SUBJECT: BROWNS FERRY NUCLEAR PLANT - CONFIDENTIAL EMPLOYEE CONCERN OVER OPERATING PRACTICES WHERE PROTECTIVE SYSTEM SIGNALS ARE BYPASSED

CONFIDENTIAL EMPLOYEE CONCERN - CASE NO. 79-10-01

Subject: TVA
Browns Ferry Nuclear Plant
Employee Concern Over Operating Practices
Where Protective System Signals are Bypassed

Figure 1

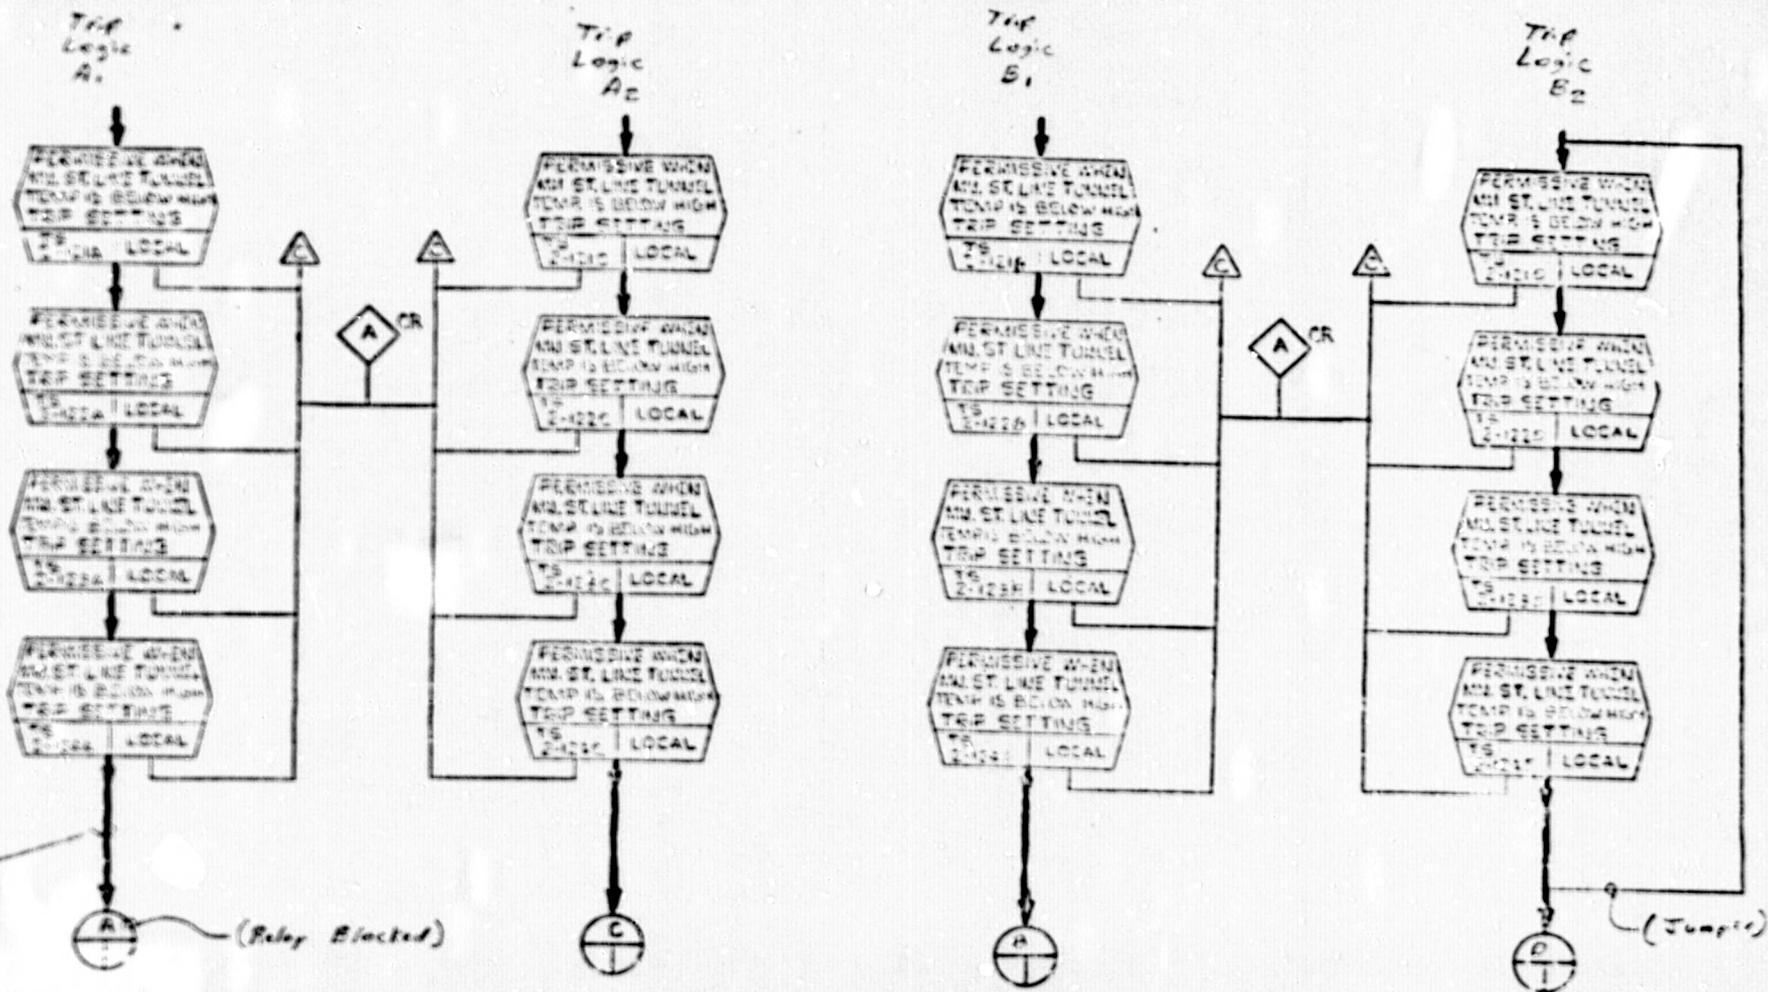
1. The sequence of events on September 26 relating to the employee concern that operating practices resulted in negating valid automatic isolation signals prior to unit 1 manual shutdown follows:
- a. Prior to 12 noon, unit 1 operating at approximately 1089 MWe.
 - b. 12 noon, received main steam half isolation signal due to steam line high temperature. Control room instrumentation and local inspection indicated that the main steam tunnel temperature was not high. Later investigation revealed that an open cable caused the half isolation signal.
- Note: The half isolation signal was from trip logic B₂. At this time, a half isolation signal from trip logic A₁ or A₂ would have automatically closed the main steam isolation valves (see figures 1 and 2).

- g. 1525 hours, jumper approved by PORC was installed.
- h. Personnel entered the steam tunnel to inspect the condition of the temperature switches. During the inspection, one of the individuals bumped a temperature switch causing a half isolation signal on trip logic A₁ and the associated relay was subsequently blocked such that an isolation signal through trip logic A₁ could not occur.
Note: In this condition, main steam line isolation would only be initiated by coincident actuation of the unmodified trip logic A₂ and B₁.

- D. Modifications should be made to the ventilation system such that a reasonable margin between normal steam tunnel temperature and isolation setpoint is maintained. The conditions that make it necessary to leave the door between the steam tunnel and reactor building open and to utilize a portable fan for ventilation should be eliminated. The Division of Engineering Design should evaluate and recommend alternatives to resolve this situation. Consideration should also be given to 1) installing more precision temperature sensors and 2) types of insulating material utilized.
